CERTIFICATE OF APPROPRIATENESS

Property: 515 Woodland Street, Lot 13, Tract 12, Block 21, Woodland Heights Subdivision. The property includes a historic 1,436 square foot one-story wood frame single-family residence and detached carport situated on a 6,200 square foot (100 x 62) interior lot.

Proposal: Alteration – Addition. Construct a 684 square foot second story atop the rear half of the existing historic structure.

Recommendation: Denial - does not satisfy criteria 1, 4, 8, 9

SOUTH ELEVATION – FRONT FACING WOODLAND STREET

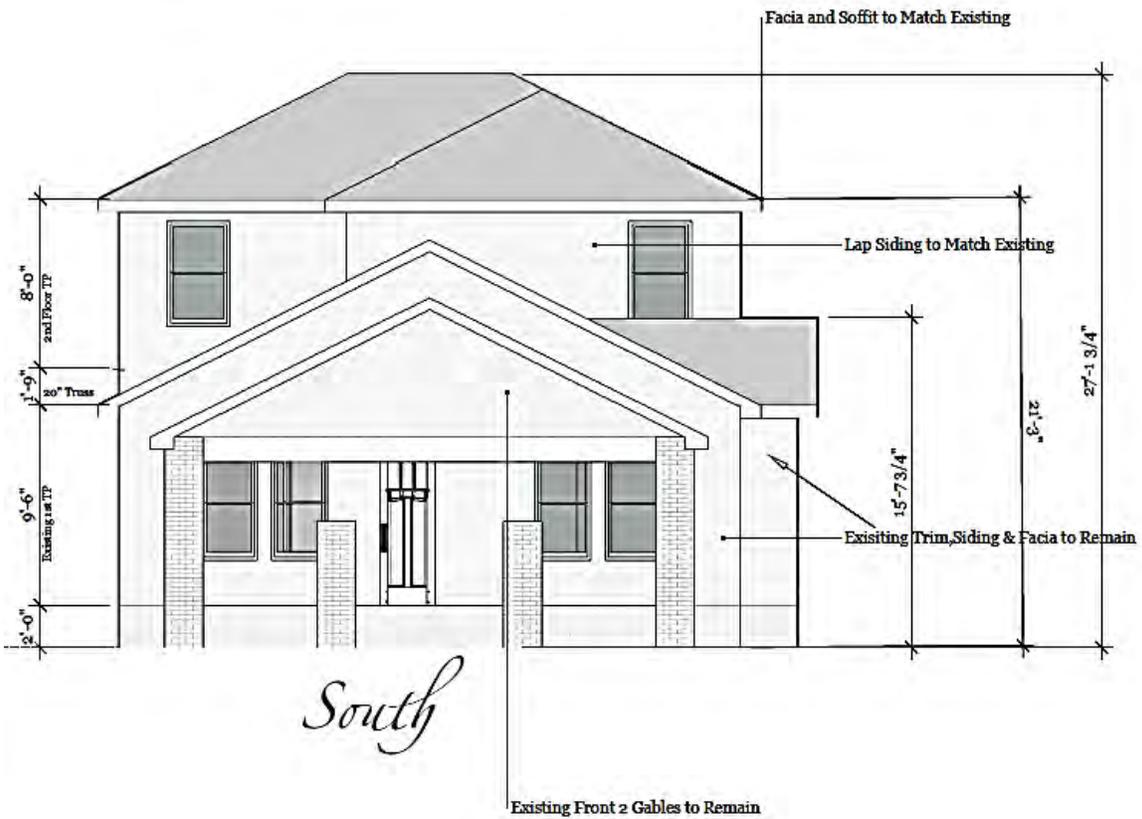
The encroachment of the proposed addition onto 50% of the original structure severely impacts the historic character of this structure and property. The second story addition will encroach 50% onto the existing structure while the rear of rear of the second story extends an additional two feet past the existing rear wall. The proposed second-story addition will also interfere with the roof configuration of the east side bump-out, altering a distinguishing characteristic of this one-story structure.

A solution to help mitigate the alteration of the bump-out roof configuration, would be to flip the proposed addition; having the deeper portion on the west side as opposed to the east side. Insetting the addition on the east and west elevations will also help demassify and the addition and preserve the original eave line.
- (2) The proposed activity must contribute to the continued availability of the property for a contemporary use;
- (3) The proposed activity must recognize the building, structure, object or site as a product of its own time and avoid alterations that seek to create an earlier or later appearance;
- (4) The proposed activity must preserve the distinguishing qualities or character of the building, structure, object or site and its environment;

A distinguishing quality of the existing home is its one-story height and relatively small scale and height and width proportion. The proposed addition alters this quality by making the house larger in scale and creating a taller height to width proportion.

The encroachment of a two-story addition over the rear half of the residence heavily alters the distinguishing character of the historic one-story residence and negatively impacts the structure visually. Additionally, the existing exterior walls (which will support the addition) were not built to support the additional load of a second-story and will have to be reinforced, leading to the potential loss of historic material including the siding and shiplap. The inclusion of a second window on the east elevation will also have a detrimental effect of the framing, siding, and shiplap. In order to maintain the original eave line, the addition should be inset on the east and west sides.
